# Access Compliance Report

## Public Rights-of-Way

### (Curb Ramps)

Intersection ID: 48073	Main Street: MALLARD_HIGHLANDS_DR	Cross Street: MALLARD_GLEN_DR	Location: W
ADA ID: 68F3C498A4BA	Ramp Type: PerpDiag	Initial Pass/Fail: Fail	Overall Compliance: No
Severity Score: 42.5			
Codes/Mitigation Info/Possible Solution		Field Measurements/Component Compliance

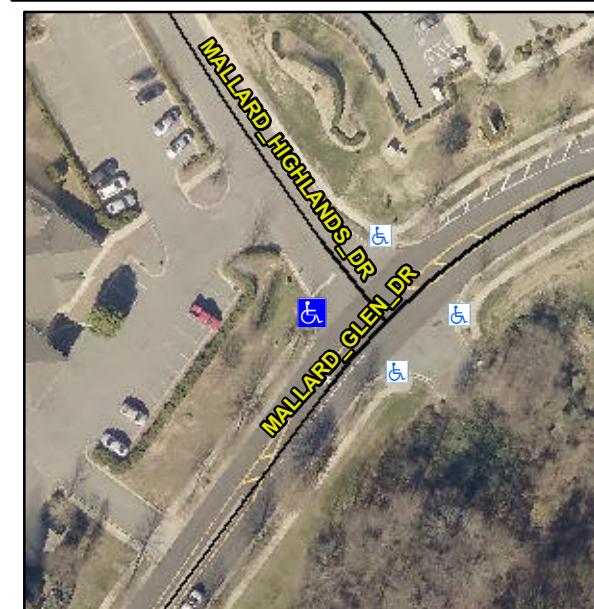
**R304.5.1, R304.2.2**

Compliance	Description	Data	Compliance	Description	Data
N/A	Ramp Length (in)	60.0	No	Ramp Slope (%)	14.0
No	Ramp Width (in)	35.0	Yes	Ramp XSlope (%)	1.6
N/A	Flare Type LT	N/A	N/A	Flare Type RT	N/A
N/A	Flare Slope LT (%)	N/A	N/A	Flare Slope RT (%)	N/A
N/A	Flare Traversable LT?	N/A	N/A	Flare Traversable RT?	N/A
N/A	Landing Length (in)	N/A	N/A	DWS Provided?	N/A
N/A	Landing Width (in)	N/A	N/A	DWS Contrast?	N/A
N/A	Landing Slope (%)	N/A	N/A	DWS Length (in)	N/A
N/A	Landing X Slope (%)	N/A	N/A	DWS Full Width?	N/A
N/A	Landing Curb? (Y/N)	N/A	N/A	DWS Offset (in)	N/A
N/A	Shared Landing?	N/A			
N/A	Gutter Ponding?	N/A	N/A	Gutter Slope (%)	N/A
N/A	Gutter Lip Ht (in)	N/A	N/A	Gutter X Slope (%)	N/A
N/A	Painted X Walk1?	No	N/A	Painted X Walk2?	No
	X Walk 1 Direction	To SE		X Walk 2 Direction	To NE
N/A	X Walk 1 Width (in)	N/A	N/A	X Walk 2 Width (in)	N/A
	X Walk 1 Slope (%)	1.8		X Walk 2 Slope (%)	2.1
	X Walk 1 X Slope (%)	2.5		X Walk 2 X Slope (%)	1.9

**Remove & Replace Curb Ramp With Two New Directional Ramps or Equivalent.**
